Re: Crown-Indigenous Relations and Northern Affairs Canada (CIRNAC) review of Water Quality and Flow Monitoring Plan – Whale Tail Project under Agnico Eagle Mines Limited's Type "A" Water Licence No. 2AM-WTP1826.

Re: Crown-Indigenous Relations and Northern Affairs Canada (CIRNAC) review of Water Quality and Flow Monitoring Plan – Whale Tail Project under Agnico Eagle Mines Limited's Type "A" Water Licence No. 2AM-WTP1826.

Project: Whale Tail Pit Project

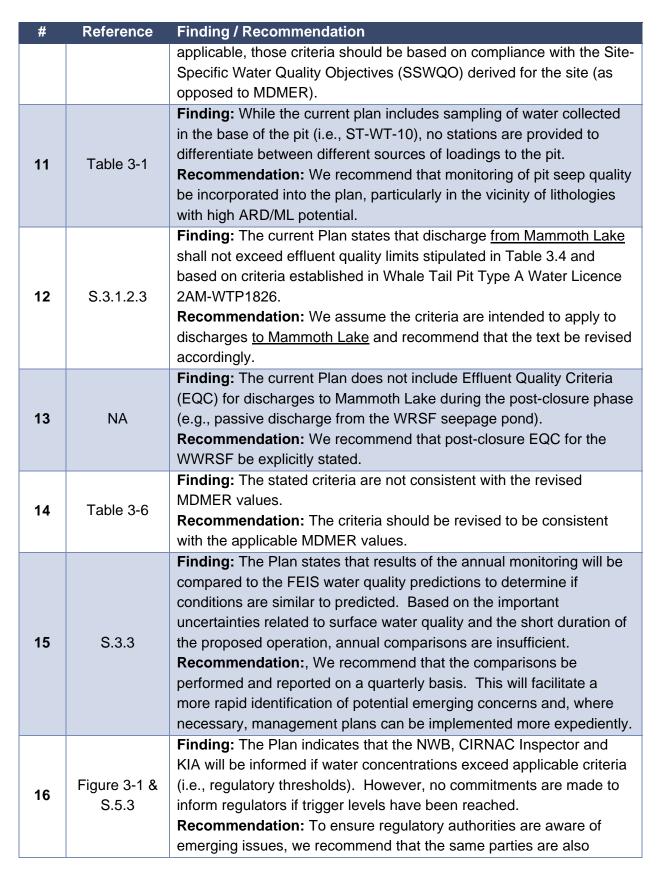
#	Reference	Finding / Recommendation
1	Figure 2-1	Finding: The current plan does not include sampling stations in Mammoth Lake immediately downstream of the drainage from the WRSF. As a consequence, there are no mechanisms to confirm that post-closure WRSF seepage discharges to the lake are environmentally protective.  Recommendation: To address this deficiency, we recommend that at least two additional stations be added to the plan within the vicinity of the discharge point (e.g., at 30 m and 60 m from the location where the WRSF enters Mammoth Lake). Sampling of the stations should be consistent with other surface water receivers of effluent (sampling frequency, analytes, depths, etc.). The sampling should begin in Year 1 of operations (to provide adequate baseline) and continue throughout the post-closure monitoring phase.
2	Figure 2-1	Finding: The current plan does not include sample collection from ST-WT-1 (Whale Tail Lake North Basin) during Year 1.  Recommendation: We recommend that sampling from Station ST-WT-1 begin in Year 1 to monitor the progression of water quality response while dewatering the North Basin.

3	Figure 2-2	<b>Finding:</b> With the exception of Figure 2-1, no water quality sampling stations are identified for the flooded South Basin of Whale Tail Lake. <b>Recommendation:</b> We recommend that two sampling stations be added to evaluate potential water quality impacts within the basin and that the monitoring continue throughout the operational life of the project, including post-closure.
4	S.2.3.4	Finding: The Plan states that post-closure monitoring to confirm physical and chemical stability is planned until 2046.  Recommendation: We recommend that the text be expanded to clarify that, depending on the findings of the post-closure monitoring and other evidence, there may be a need to modify the duration of the post-closure monitoring until such time that site stability has been confirmed.
5	S.3.1	Finding: The Plan indicates that non-contact water discharged from diversion ditches and other surface water drainages will be sampled. However, no sampling stations are identified.  Recommendation: While we appreciate that the exact locations of non-contact water sampling stations are subject to change, we recommend that the Plan identify the key drainage paths/catchments and approximate station locations that are likely to be incorporated into the sampling regime.
